Addendum No. 1
May 3, 2022

Project: Webster Area School – 2022 CTE Addition & Remodeling
Webster, South Dakota
Architecture Incorporated Project #2936

Scope of this Addendum:

9.23-C

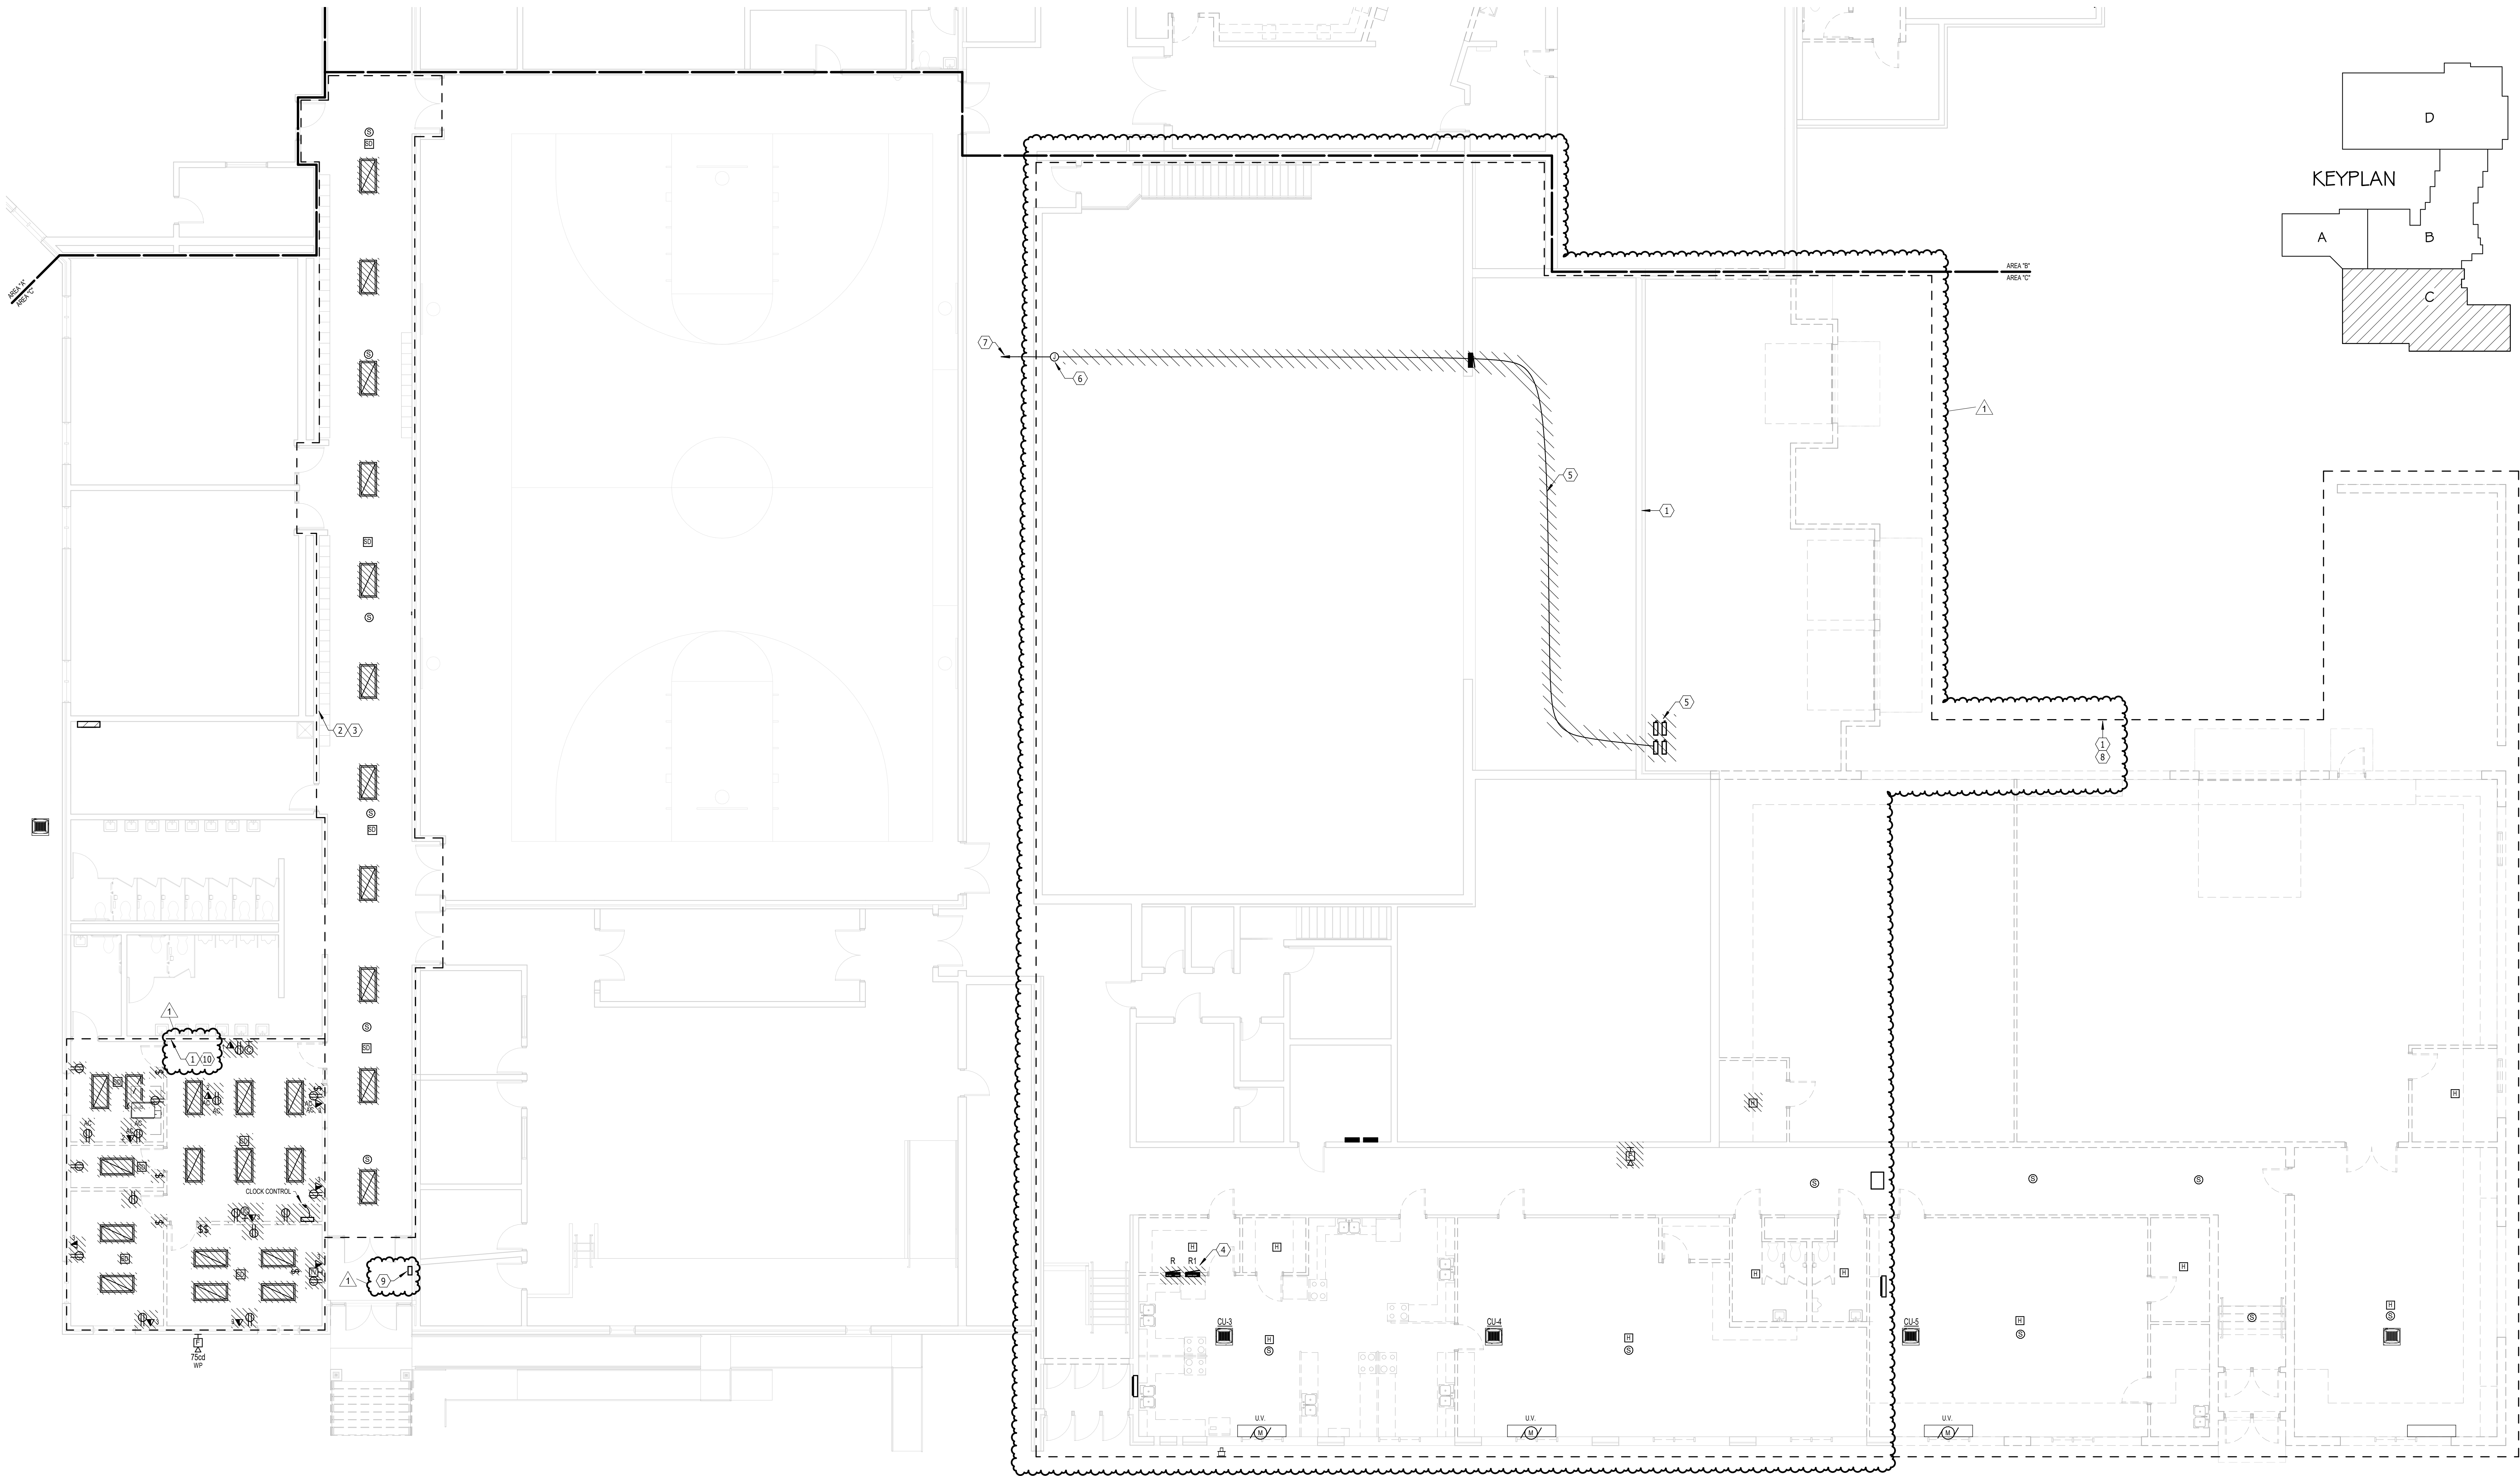
2) DRAWING SHEET 9.23-C – DEMOLITION PLAN – AREA C – ELECTRICAL

- a) See the attached revision drawing.

9.31-A1

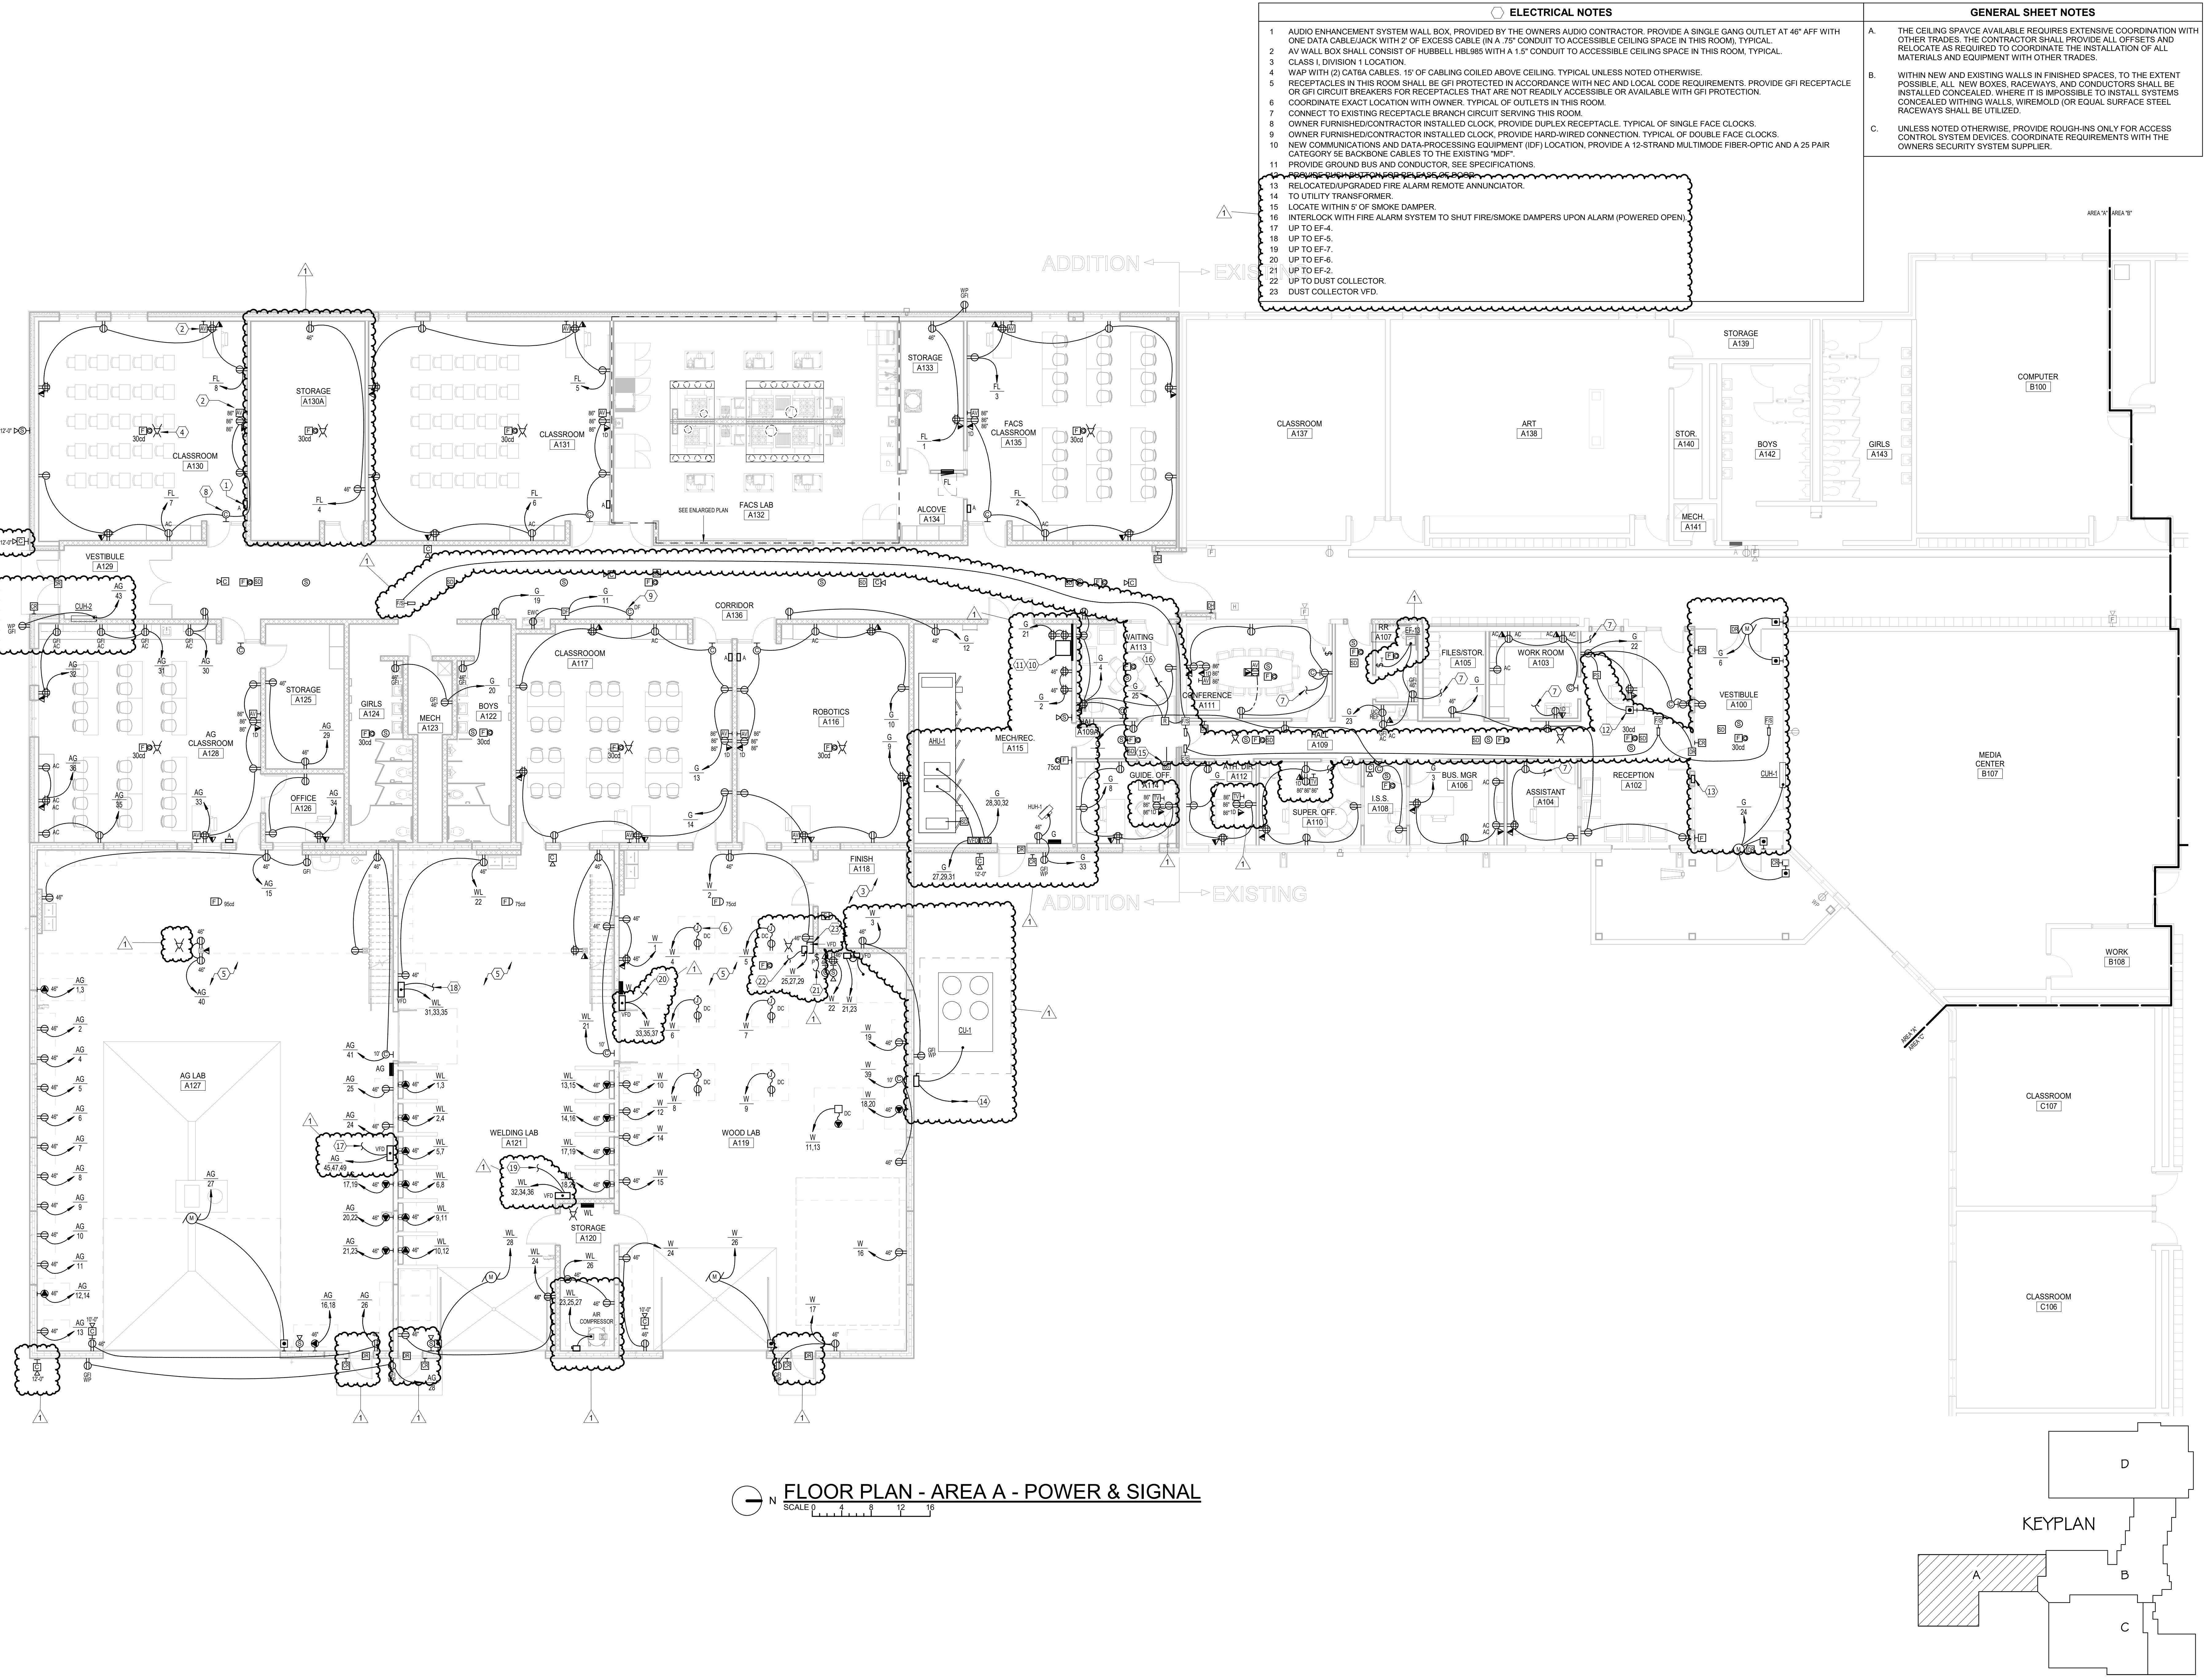
3) DRAWING SHEET 9.31-A1 – FLOOR PLAN – AREA A – LIGHTING

- a) See the attached revision drawing.

9.32-A1

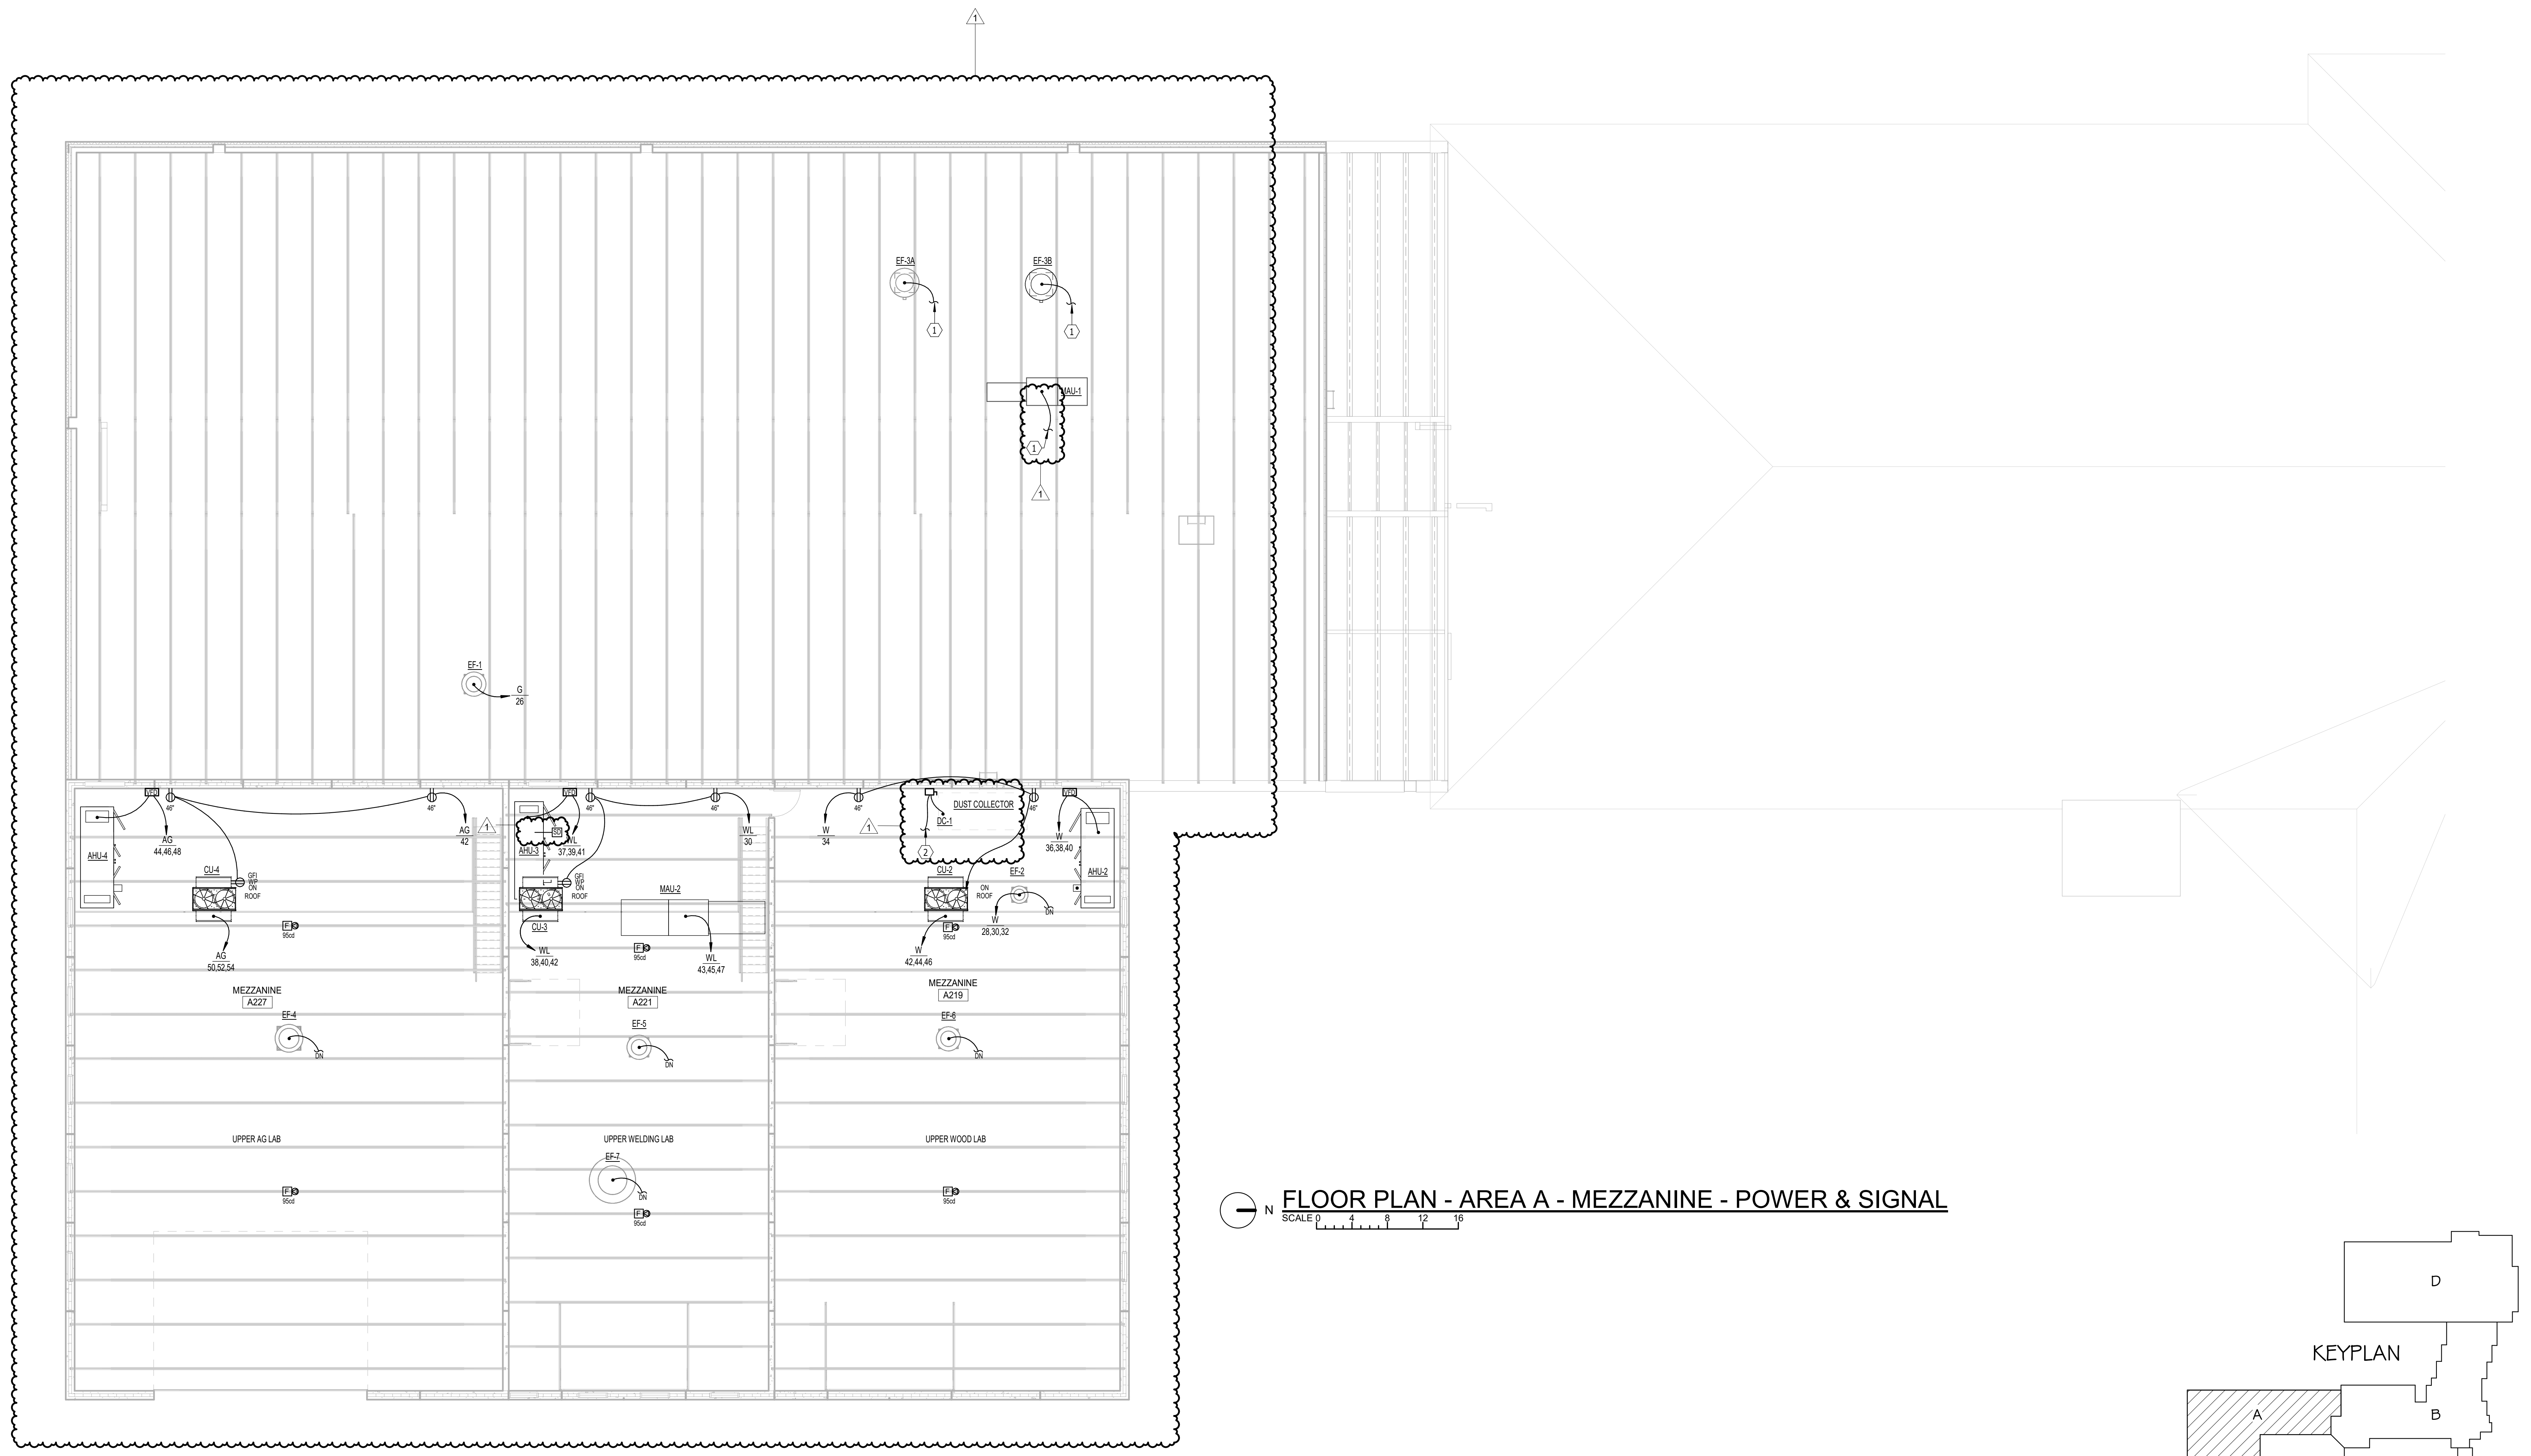
4) DRAWING SHEET 9.32-A1 – FLOOR PLAN – AREA A – POWER & SIGNAL

- a) See the attached revision drawing.
